**CHANGE ORDER**

Contract: Road Maintenance 2016

Project: P160302-1

No. 2

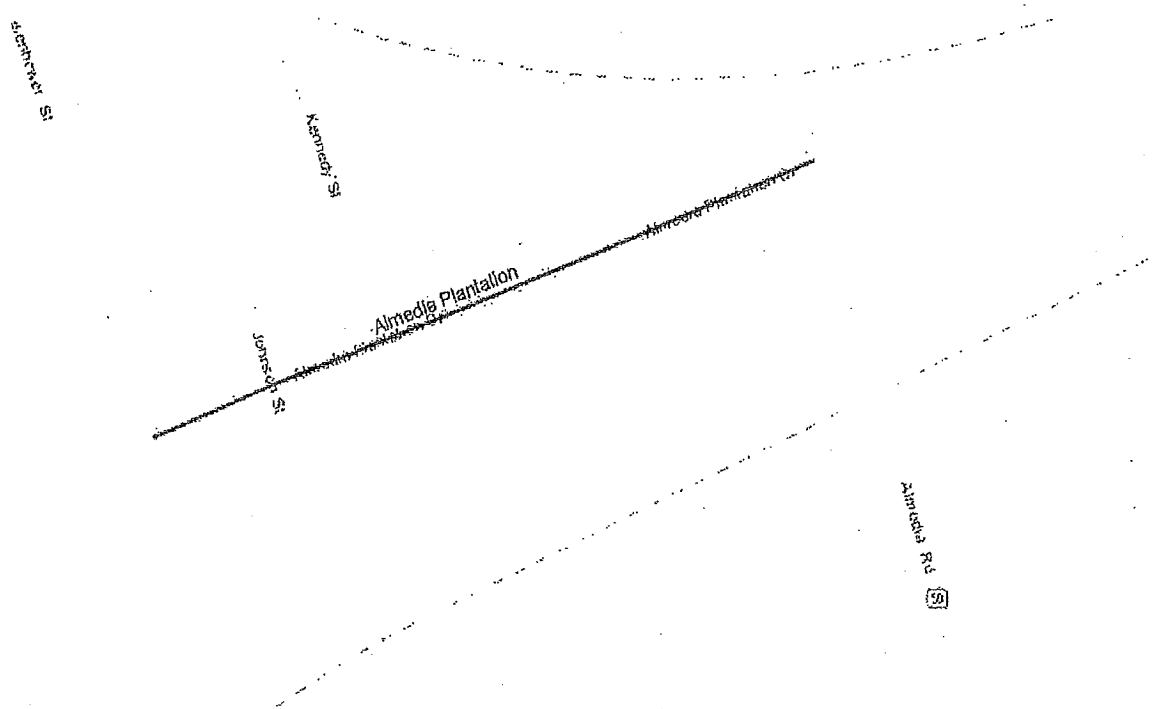
Description: Breaux Ln. was found to be a private street; therefore, it is being removed from the project. The approximate cost savings for not performing work on Breaux is \$12,184.63. Almedia Plantation Dr. and Johnson St. are to be added to the project. Each of these streets will receive patching, mill, overlay, shoulder material, etc. The estimated costs for the additional work are \$49,942.25 for Almedia Plantation Dr. and \$61,101.00 for Johnson St. Mill, overlay, shoulder material, etc. on Kennedy St. will also be added to the project. The estimated cost for the additional work on Kennedy St is \$28,794.50. In addition, a \$7,000 mobilization will be added to the project.

Attachments: (List documents supporting change): See attached for maps of Almedia Plantation Dr., and Johnson St. A map of Kennedy St. was previously provided.
